1 - 7 ANDREWS AVENUE, 26 GLEN STREET, BONDI NSW

ADAPTABLE HOUSING ASSESSMENT – AS4299-1995

REPORT NO: 2868 – REV E FINAL

Figure A – Bollards required within Shared areas of Accessible carparking spaces on basement level

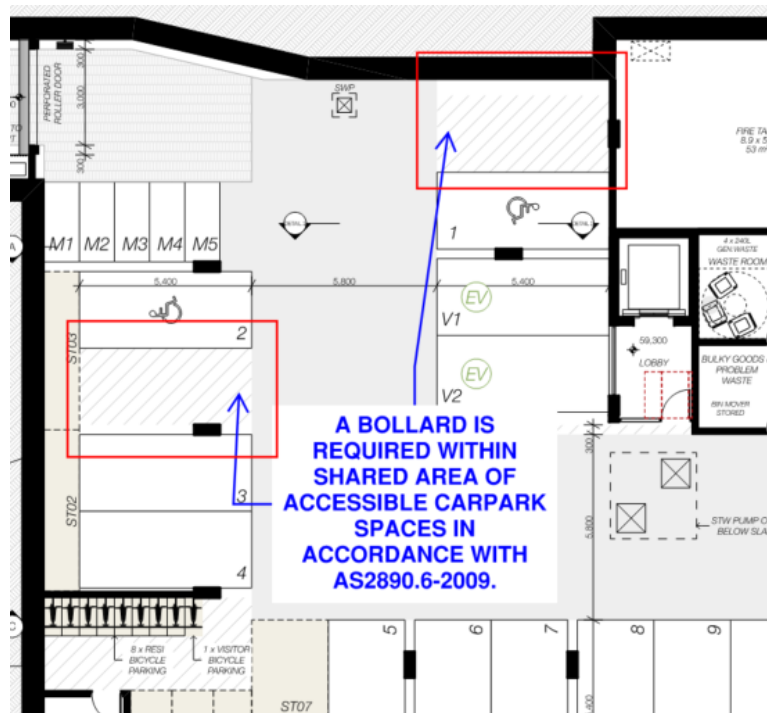
1.	3.7.2	Private Car Accommodation Two accessible carparking spaces with adjacent shared areas have been provided within the basement carpark. A bollard is required to be provided within the shared areas in accordance with AS2890.6-2009.	Details demonstrating compliance with this Clause are required to be incorporated within the Construction Certificate documentation.
----	-------	---	--

Figure B - Door circulation (External latch width and internal length) is not achieved on unit entry door.

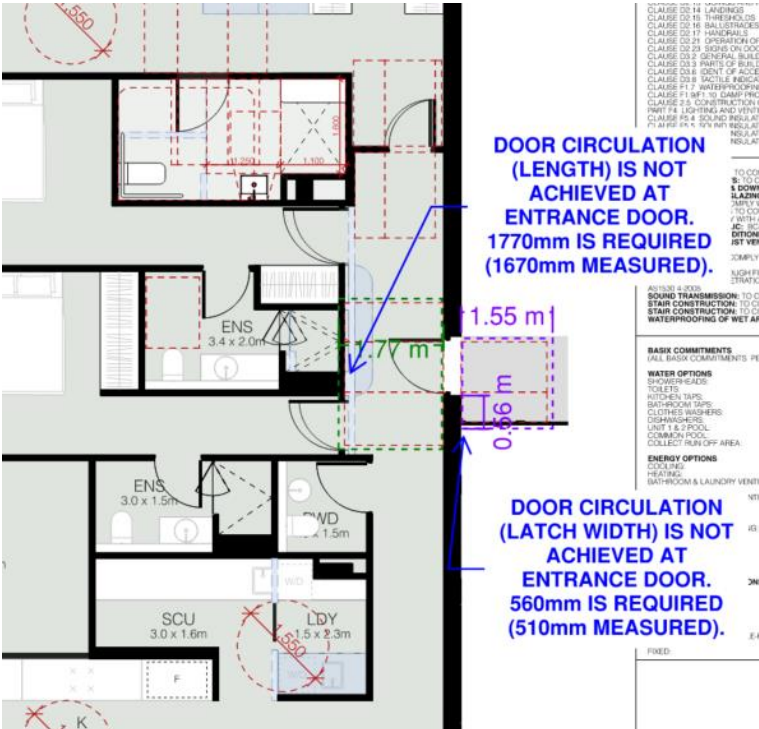
NO.	ADAPTABLE CLAUSE	DESCRIPTION OF NON-COMPLIANCE	RECOMMENDATION
2.	4.3.1	<p>Accessible entry</p> <p>At least one accessible entry door complying with AS1428.2 shall be provided.</p> <p>Door circulation under AS1428.2 has not been achieved at the entry doors to the adaptable units. An external latch width of 560mm (510mm measured) and internal length of 1770mm is required. AS1428.2 requires an additional 50mm to be added to all width dimensions and 100mm to be added to all length dimensions required by AS1428.1.</p> 	To be redesigned to comply.

Figure C- Internal door widths do not achieve minimum required (820mm)

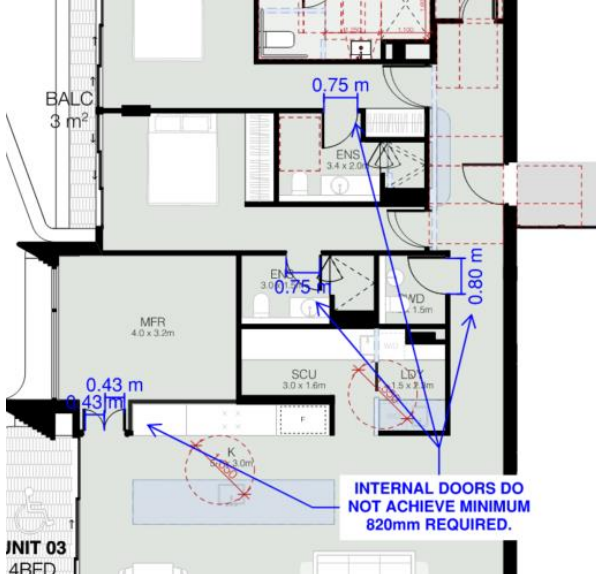
NO.	ADAPTABLE CLAUSE	DESCRIPTION OF NON-COMPLIANCE	RECOMMENDATION
3.	4.3.3	<p>Interior General – Internal Doors</p> <p>Internal doors are required to achieve a minimum of 820mm throughout.</p> <p>Internal doors in the following areas do not achieve the required minimum width:</p> <ul style="list-style-type: none"> • Bedroom 2 ensuite door • Bedroom 3 ensuite door • Powder room • MFR room 	To be redesigned to comply.
4.	4.5.6	<p>Kitchen Sink - Kitchen sink adjustable to heights from 750mm to 850mm or replaceable</p> <p>Architectural plans do not indicate location of the kitchen sink post-adaptation. It is preferred that the sink is not located within the island benchtop to minimize the cost of later modification to the floor and plumbing work.</p>	To be redesigned to comply.

Figure D – Main bedrooms within adaptable units do not provide adequate circulation space under AS1428.2

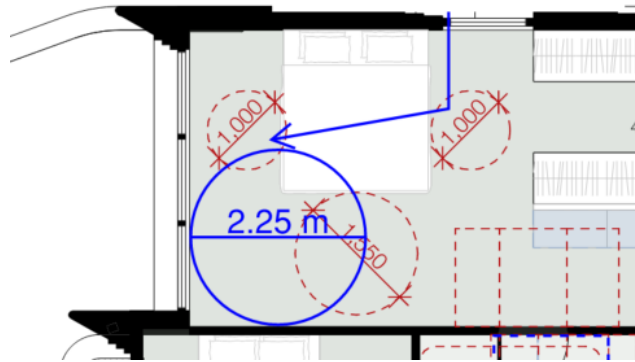
NO.	ADAPTABLE CLAUSE	DESCRIPTION OF NON-COMPLIANCE	RECOMMENDATION
5.	4.6.1	<p>Main Bedroom</p> <p>At least one bedroom of area sufficient to accommodate queen size bed and wardrobe and circulation space requirements of AS1428.2.</p> <p>The master bedrooms in both units allow for a queen size bed and wardrobe but do not provide sufficient circulation space under AS1428.2 for a wheelchair to undertake a 360° turn. This requires a circulation space of 2250mm x 2250mm to be provided as shown below.</p>	<p>To be redesigned to comply.</p> <p>We note that the application of AS4299-1995 is that objective is for at least one bathroom, toilet and bedroom, living and laundry to be capable of complying with the standard. This is considered the benchmark level of compliance.</p>

CIRCULATION SPACE OF 2250mm x 2250mm IS REQUIRED FOR 360 DEGREE TURN UNDER CLAUSE 6.3 OF AS1428.2-1992.

Figure E – Wardrobe is located within turning space along path of travel

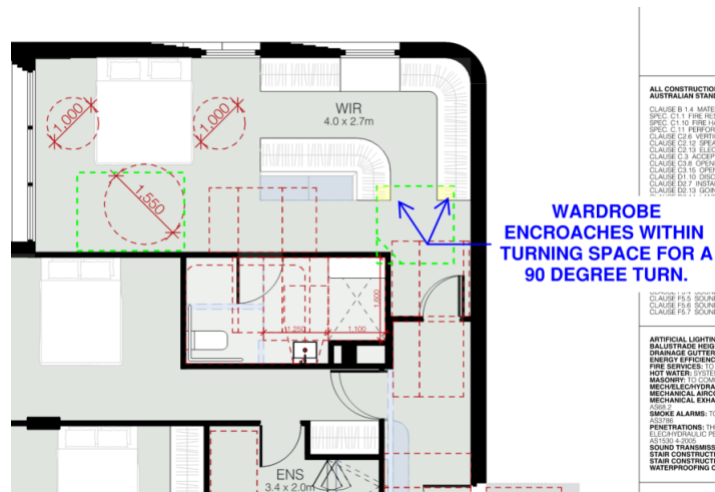
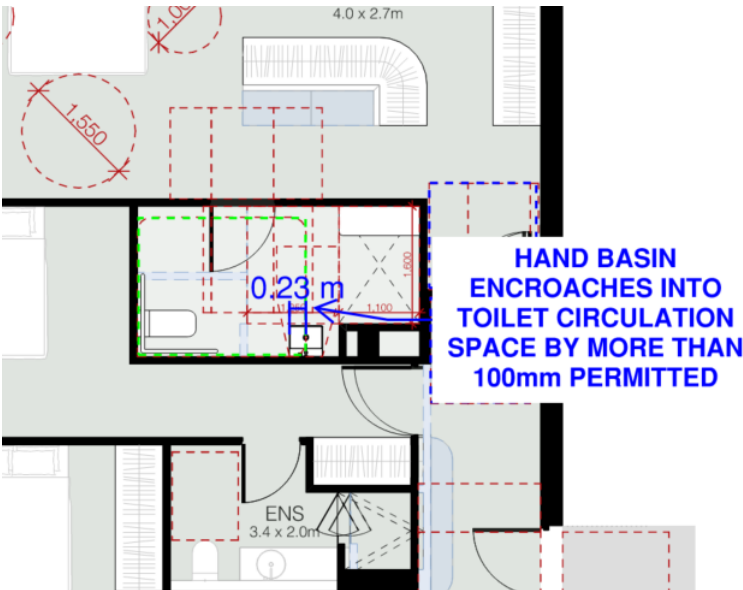
Additionally, the wardrobe is located within the circulation space to enable a wheelchair to undertake a 90° turn from/to the bedroom door.

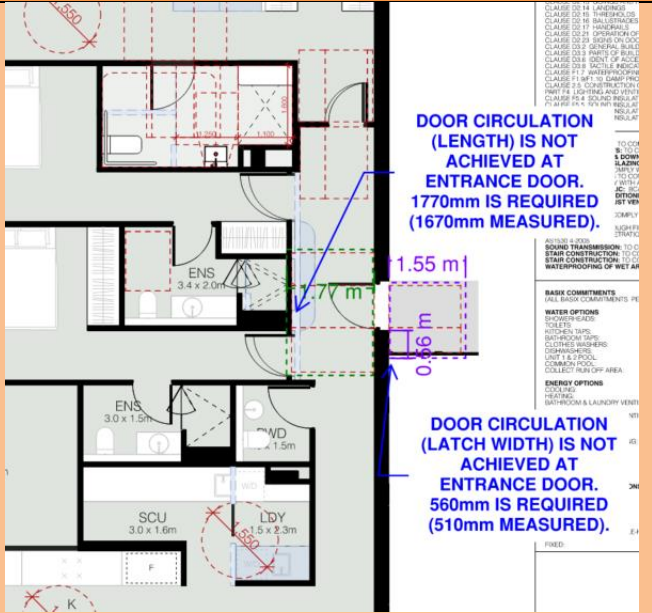
14.	Carparking space or garage min. area 6.0m x 2.8m	3.7.2	✓	X	Two accessible carparking spaces with adjacent shared areas have been provided within the basement carpark. A bollard is required to be provided within the shared areas in accordance with AS2890.6-2009.
-----	--	-------	---	---	--

Figure 6 – Main bedrooms within adaptable units do not provide adequate circulation space under AS1428.2

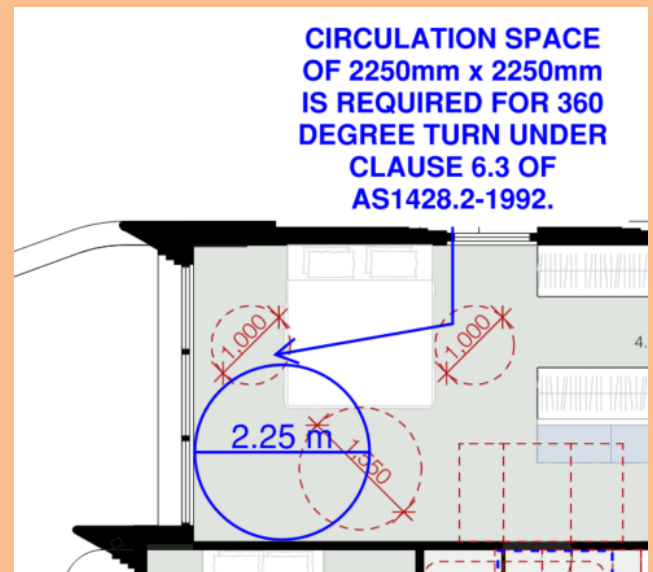
62.	At least one bedroom of area sufficient to accommodate queen size bed and wardrobe and circulation space requirements of AS1428.2	4.6.1	✓	X	The master bedrooms in both units allow for a queen size bed and wardrobe but do not provide sufficient circulation space under AS1428.2 for a wheelchair to undertake a 360° turn. This requires a circulation space of 2250mm x 2250mm to be provided as shown below.
-----	---	-------	---	---	---

Figure 7 – Wardrobe is located within turning space along path of travel

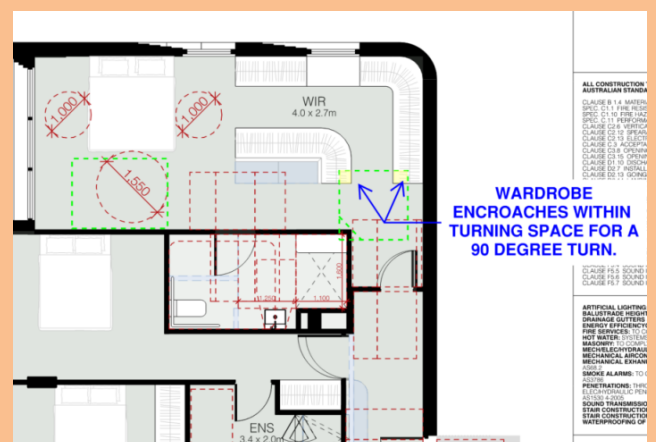
Additionally, the wardrobe is located within the circulation space to enable a wheelchair to undertake a 90° turn from/to the bedroom door.
